**Product Change Notification:** E-17-018606

**General Product Description:**  
776231 35 Position AMPSEAL Vertical Header Assembly

776231-5 & 1-776231-5  
KEY LOCATION  
SCALE 2:1

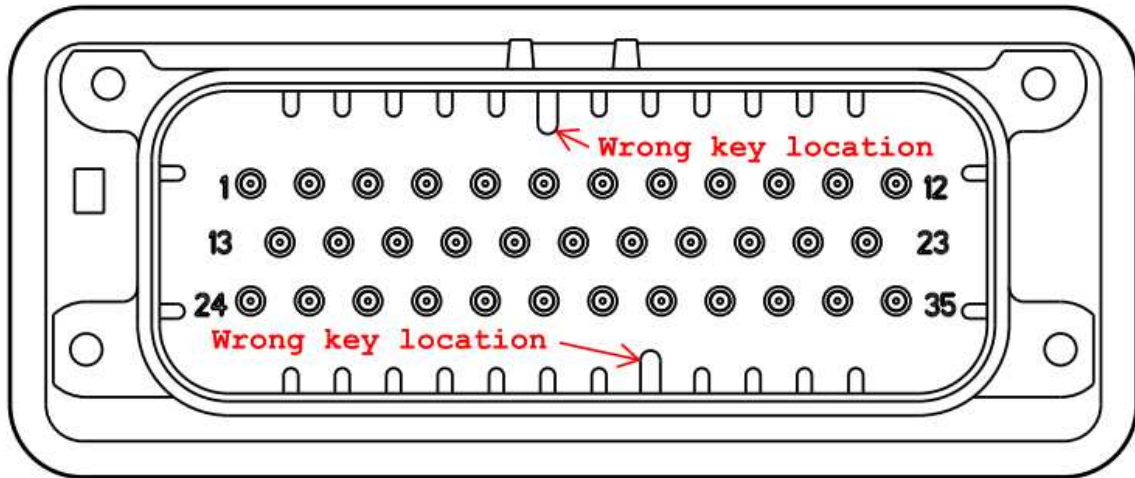
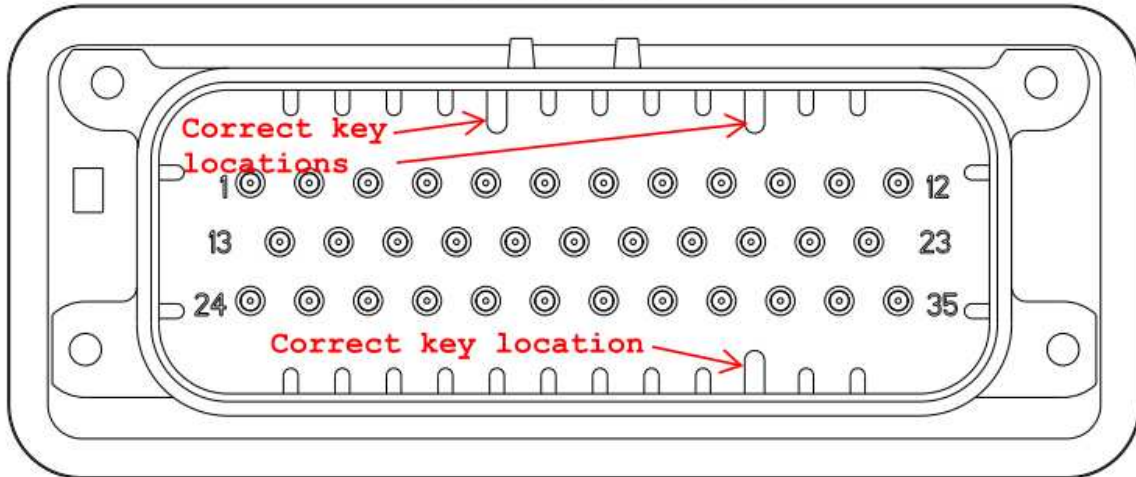
**Description of Changes**  
The header view on Sheet 2, Zone A-7/8 did not show the correct keying for PNs 776231-5 and 1-776231-5. Updated this view to show the correct keying inside the header shroud The drawings for the listed part numbers have been modified to correct following; Before: After:  
**Other attachments:**  
[PCN-17-018606](#)

**Current incorrect key locations**

**Corrected view**

**776231-5 & 1-776231-5**  
KEY LOCATION  
SCALE 2:1
